## Flood Risk Assessment

### Strategic Housing Development

**Clonkeen College, Clonkeen Road,  
Blackrock, Co. Dublin**

## 5.0 RESPONSE TO ABP OPINION

Architect	Scott Tallon Walker			
Project	Proposed Development at Clonkeen Road			
Title	Drainage Ditch Assessment Drainage Catchment Area			
Dwn by	Chkd by	Aprvd by	Dwg. No.	Revision
JMC	RFM	RFM	W012-SK01	
Date	Scale			
Jun 2021

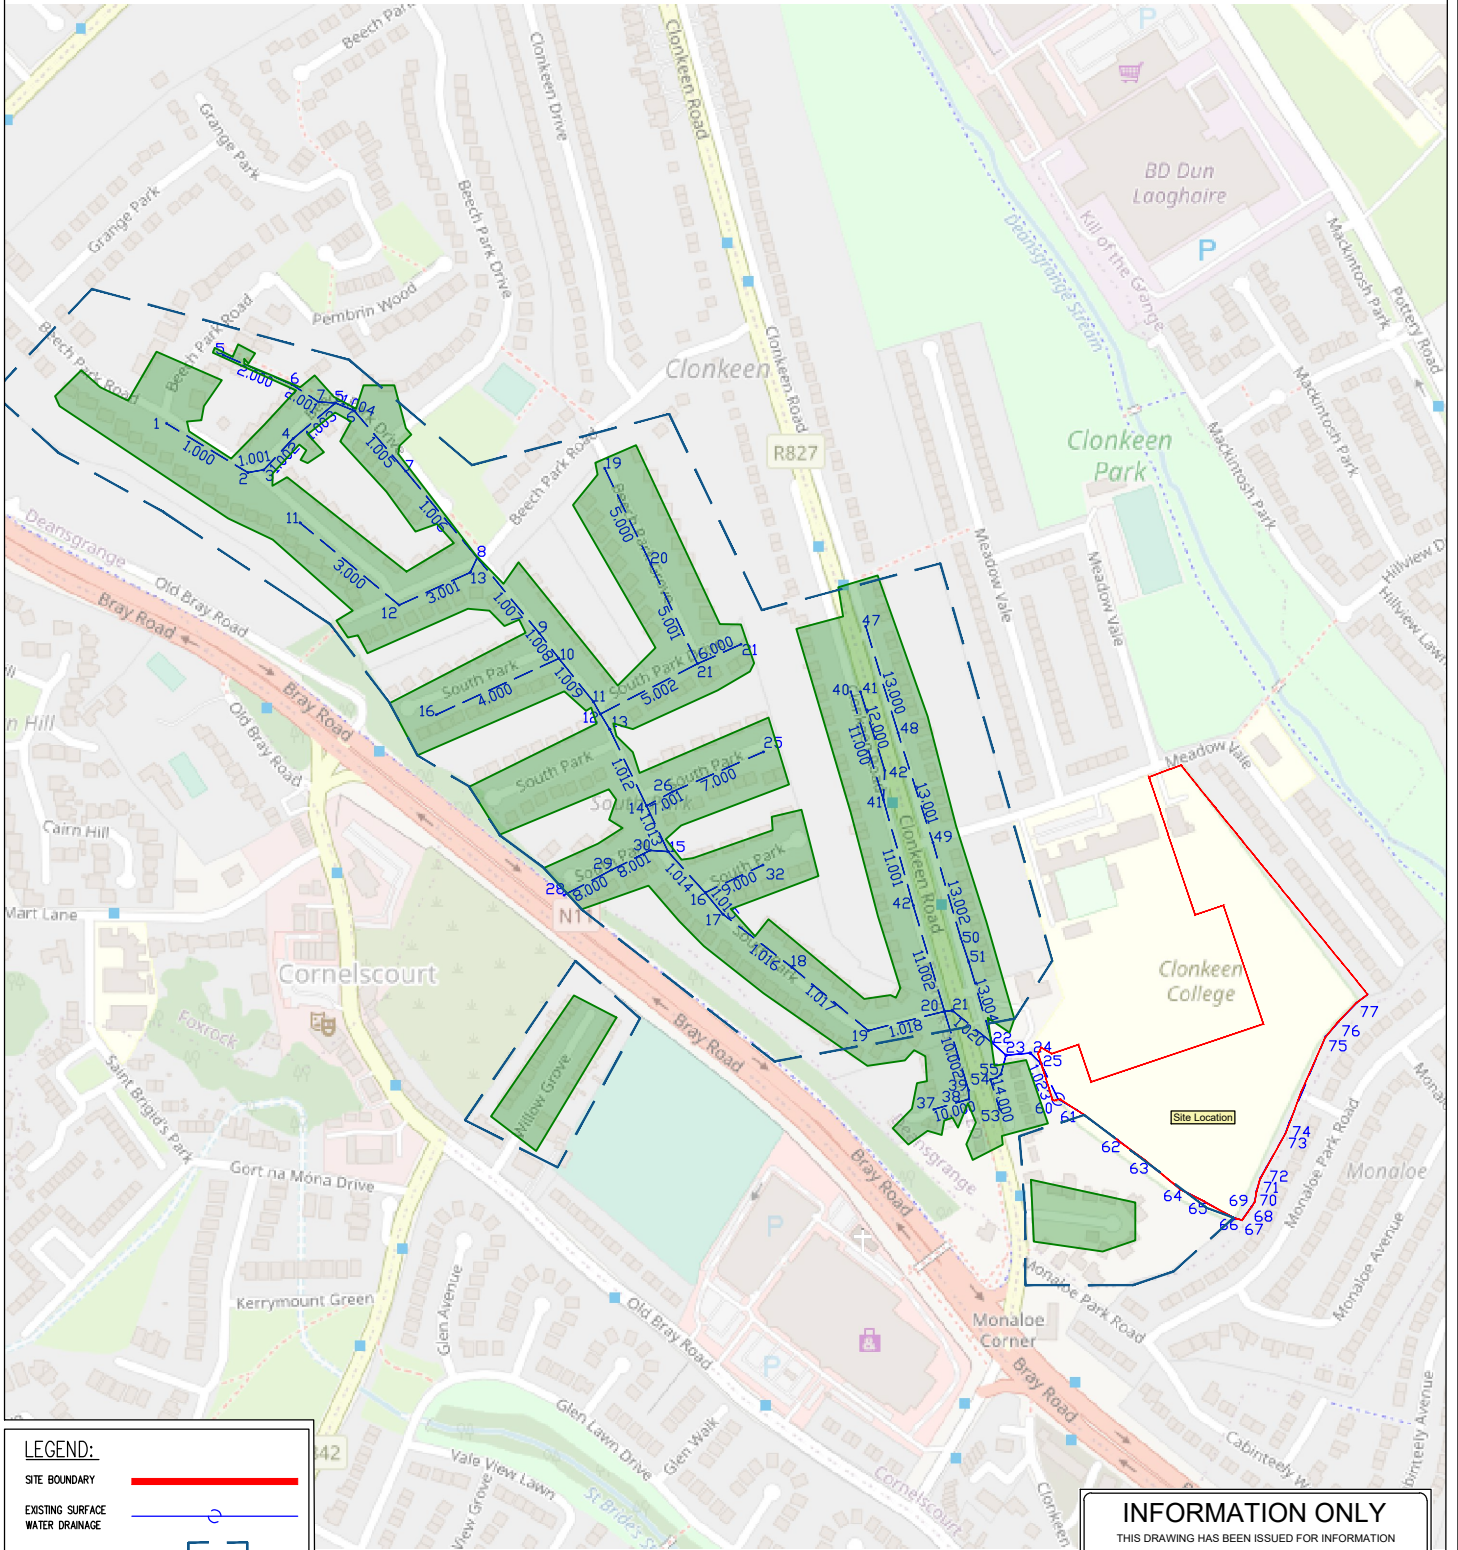
*It is acknowledged that the applicant has submitted a Site Specific Flood Risk Assessment, (SSFRA), however, it does not fully address the watercourse to the south of the site and any possible flood risk it may pose. The applicant should note that no highly vulnerable development is allowed in either Flood Zones A or B (existing, under development scenario). This assessment also does not address failure of the proposed surface water system and its impact on the development and adjacent lands.*

1. *The applicant is required to resubmit their SSFRA with a more comprehensive assessment of the watercourse to the south of the site, this assessment may require hydraulic modelling, including an accurate survey of existing channel bed and bank. Any alteration of existing topography within the flood extents zone must be accounted for in the modelling exercise. The following as a minimum must be included in the SSFRA, in accordance with Appendix 13 (Strategic Flood Risk assessment) of Dun-Laoghaire-Rathdown County Development Plan 2016 – 2022;*
  - a. *Flood extents and depth maps for the 1.0% AEP and 0.1% AEP flood events for both existing and proposed scenarios, with the development footprint superimposed.*
  - b. *Cross sections are required at regular intervals and at a suitable legible scale to show the extent and depth of out of bank flood*

1. CS Consulting looked at the ditch to the south of the south and developed cross sections for same to allow an accurate calculation of the conveyance capacity of the ditch. In addition, the surrounding catchment which feed into the inlet pipe entering the ditch was also established and modelled to check the hydraulic capacity of the existing public drainage network. Drawing **W012-SK01** in **Appendix E** give the location and area of

The existing public storm water catchment to the west of the subject lands, as indicated in W012/SK01, was modelled using WinDes hydraulic software. The model was run for the 1.0% AEP (annual exceedance probability of 1-in-100 years) & for the 0.1% AEP (1-in-1000 years) both the modelling events were factored up by 20% for the predicted affects of climate change. Refer to **Appendix F** for WinDes model calculations.

Architect	Scott Tallon Walker			
Project	Proposed Development at Clonkeen Road			
Title	Drainage Ditch Assessment Drainage Ditch Volume			
Drm by JMC	Chkd by RFM	Aprvd by RFM	Dwg. No.	Revision
Date Jun 2021	Scale		<b>W012-SK03</b>

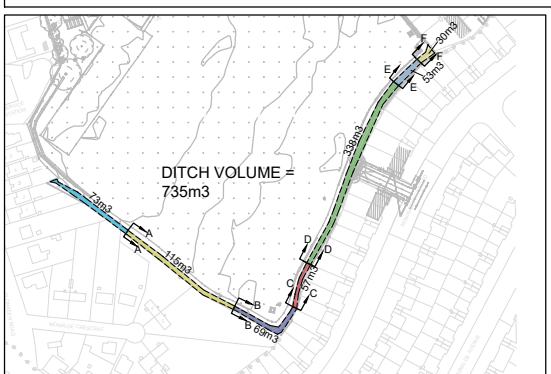
*flooding, if any, for the 0.1% AEP and 0.1% AEP flood events for both existing and proposed development scenarios.*

- c. Sections at the outflows from the site that show they are above the 1.0% AEP flood depth.*
- 2. The applicant must ensure that the flood flow-path areas do not contain any Engineering, Architectural, or Landscape features, (other than proposals submitted as part of the planning application) that would have the potential for obstruction of flowpaths.*

the offsite catchment modelled. Drawing **W012-SK02** gives a simplified flow path route based on the cover levels of the manholes on the storm water system. Also, as requested cross sections for the ditch were generated allowing the cross-surface area to be accurately determined to aid in modelling the capacity in the ditch, see drawing **W012-SK03**.

- a. No on site flooding predicted for the 1.0% or 0.1% flood events.
- b. See drawing **W012/SK03** for cross sections of the ditch, but no 1.0% or 0.1% out of bank flooding predicted.
